141 Riverview Road, Avalon

Comments on updates to Plans

We have reviewed the existing geotechnical report, the plans used to carry out the report, and the updated plans for DA shown on 19 drawings prepared by Fyffe Design, job number 20127, drawings numbered DA01 to DA19, Issue 08, dated 21/6/21.

Photo 4

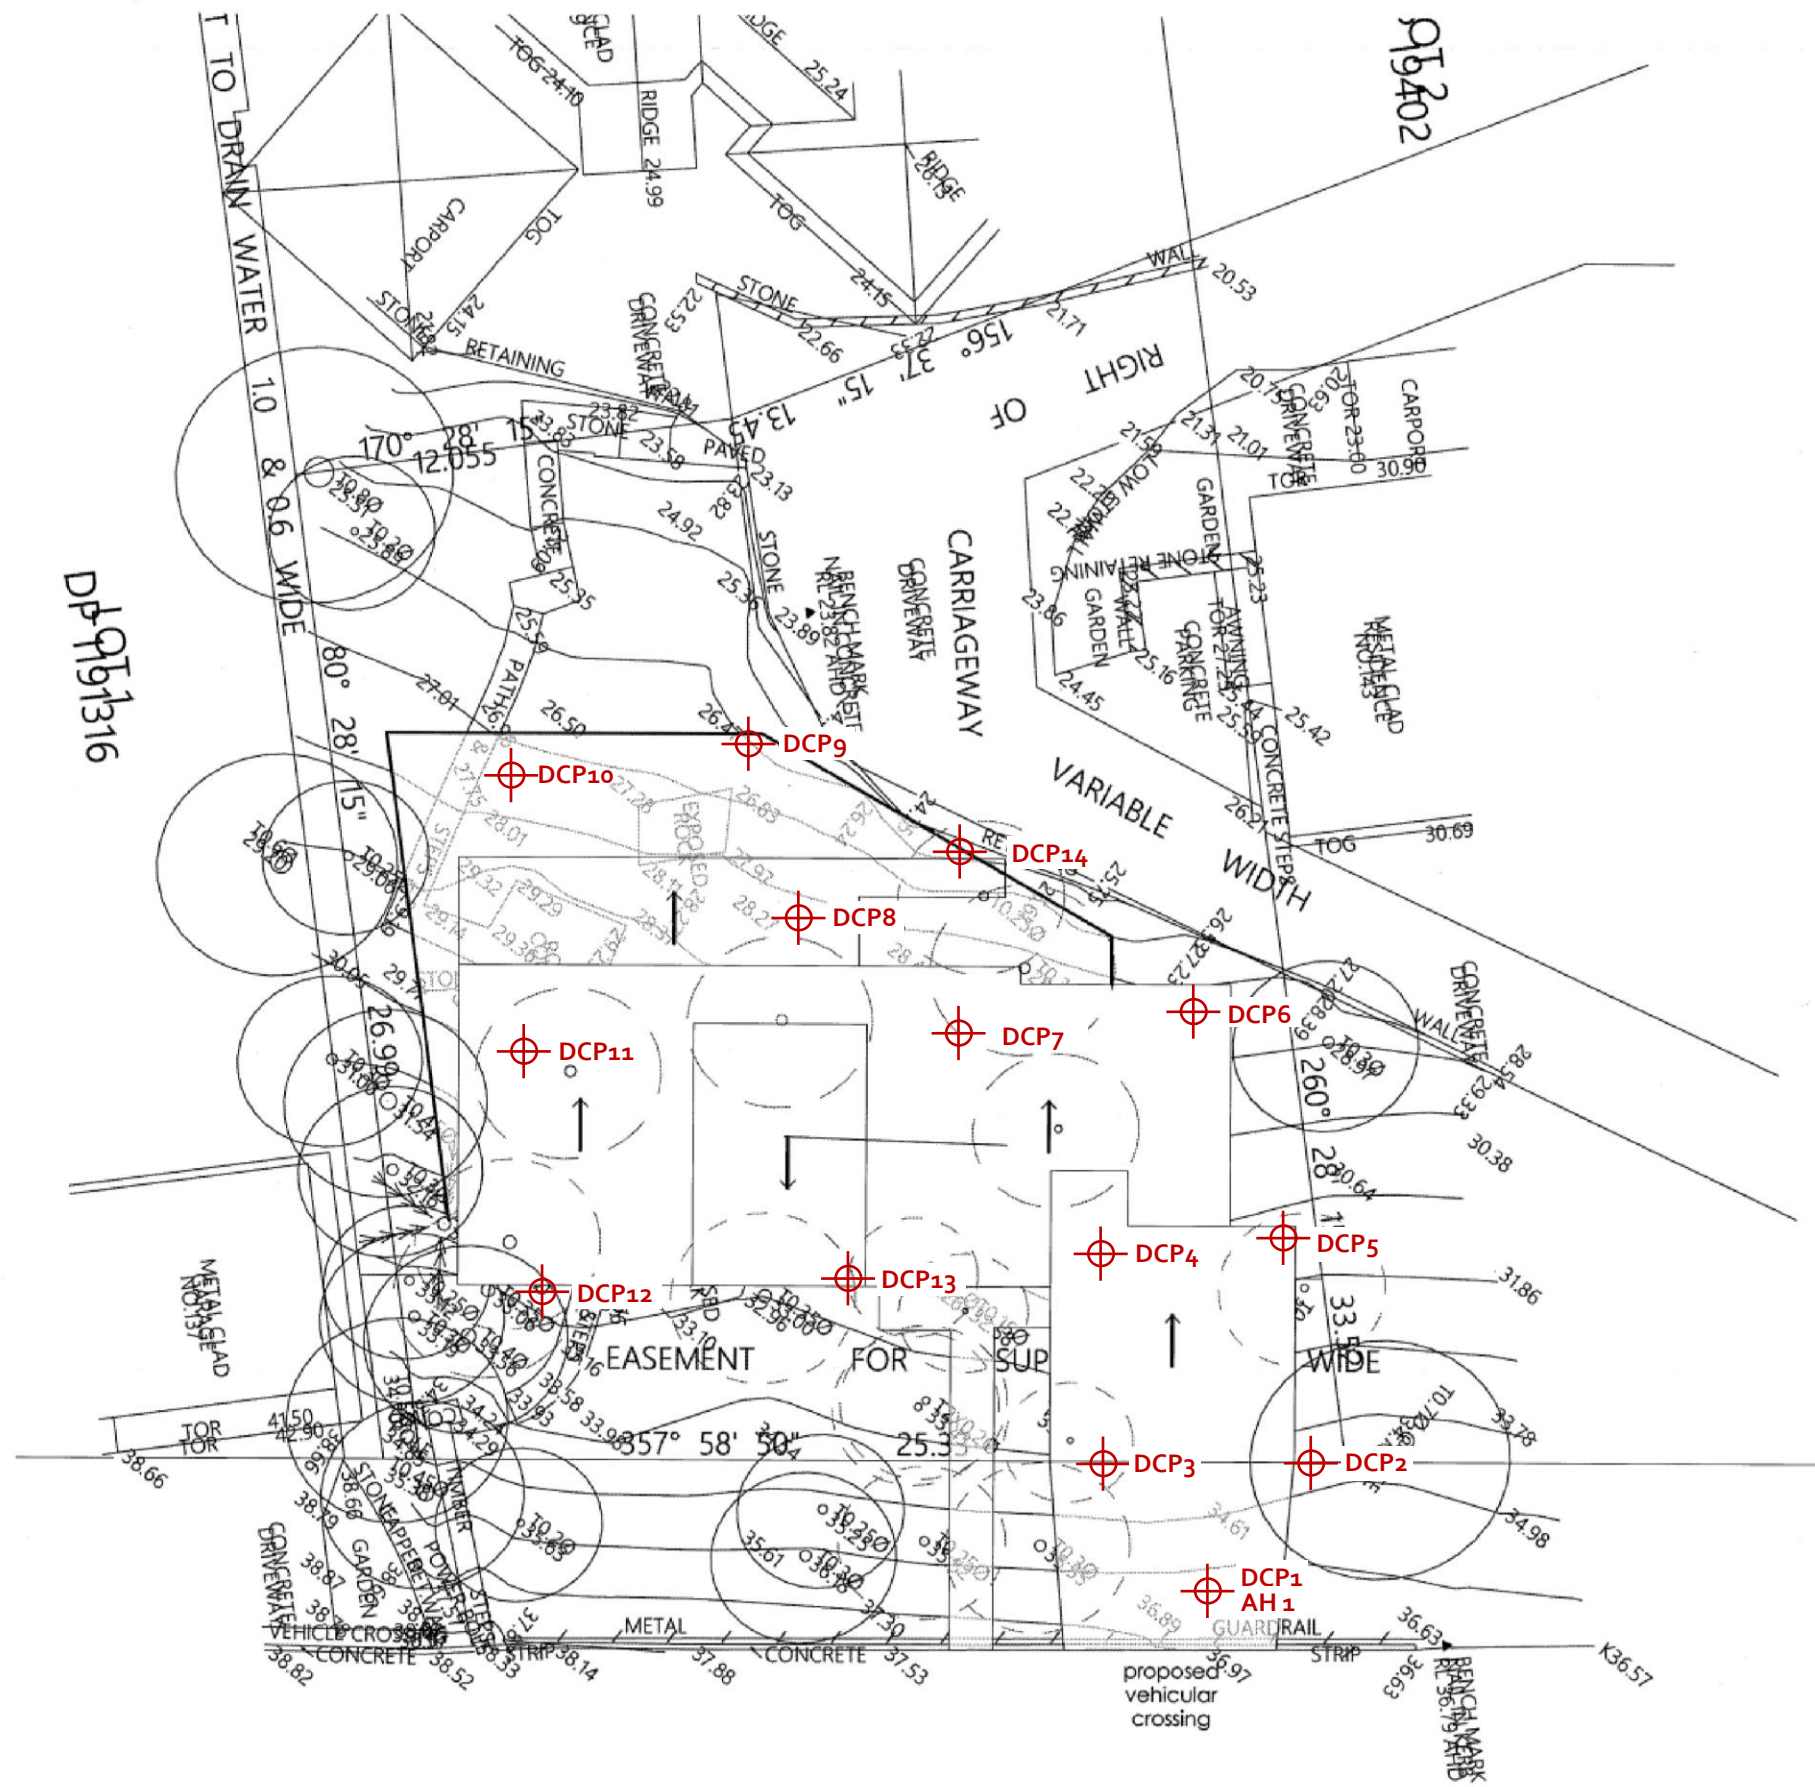
Fill will be placed for landscaping purposes on the downhill side of the proposed house. The proposed fill is located above an existing sandstone flagging retaining supporting the cut for the right of carriageway below (Photo 4 in the original report). The sandstone flagging retaining wall is to be demolished from the top down prior to the filling commencing. The soil and clay immediately behind the wall is to be battered at 1.0 Vertical to 1.7 Horizontal (30°) as the wall is lowered and demolished.

No fills are to be laid until the new engineered retaining walls are in place.

The fill will reach a maximum depth of ~2.2m. Filling to this depth without appropriate compaction will result in a significant settlement. To avoid excessive settlement, the fill is to be placed in loose layers not exceeding 0.2m thick before being compacted as follows:
